WALSH BAY ARTS AND CULTURAL PRECINCT

SSDA 8671

BCA ASSESSMENT REPORT

Phase 2 - State Significant
Development Application

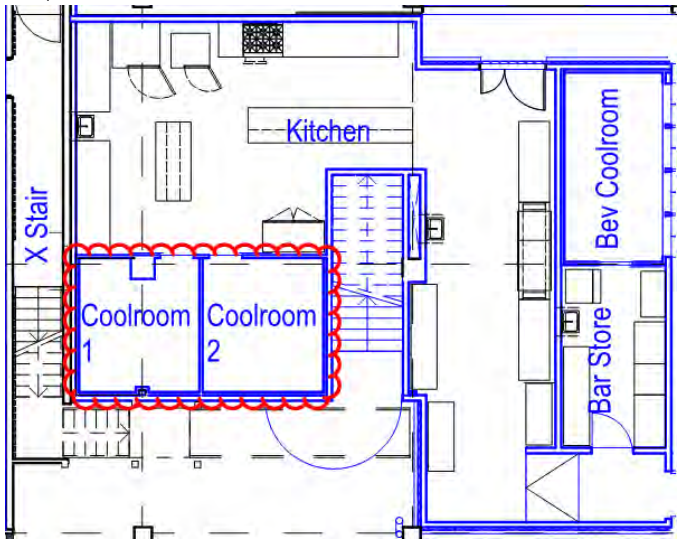
PART F3 Room Sizes		
F3.1	Height of rooms	<p>Does Not Comply / Performance Solution</p> <p>The ceiling height must be not less than:</p> <ul style="list-style-type: none"> (i) Generally: 2.4m. (ii) Class 9b parts accommodating more than 100 people: 2.7m (iii) Commercial Kitchen: 2.4m (iv) A corridor, passageway, or the like: 2.1m (v) A sanitary compartment, airlock, tea preparation room, pantry, store room, or the like: 2.1m. <p>The referenced plans do not indicate that compliance with the above requirements will not be achieved in various locations within Pier 2/3 as follows;</p> <p>Particular attention will need to be paid to areas located below existing structural beams and trusses and spaces below the non-fire isolated stairways which create a head height obstruction by virtue of their position within the building</p> <p>The reduced heights and projections will need to be addressed through the development of an Performance Solution Report by a suitably qualified BCA Consultant which demonstrates that Performance Requirement FP3.1 is satisfied</p>

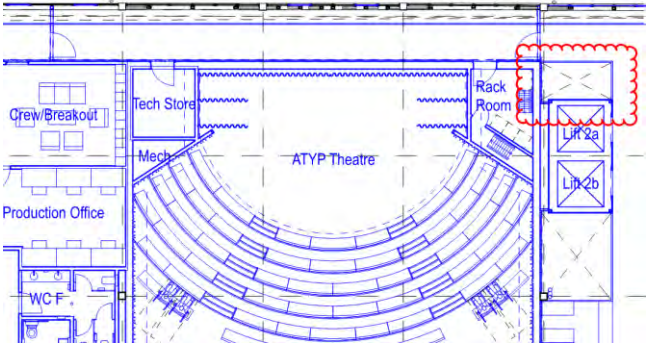
F4.9	Airlocks	<p>Note</p> <p>Within a class 5, 6,7,8,9 building where prohibited to open directly to another room under F4.8 above, access needs to be via an airlock, hallway or other room with a floor are of not less than 1.1m² and fitted with self-closing doors, alternatively the sanitary compartment must be provided with mechanical exhaust ventilation and the doorways to the room adequately screened from view.</p>
F4.10	Repealed	-
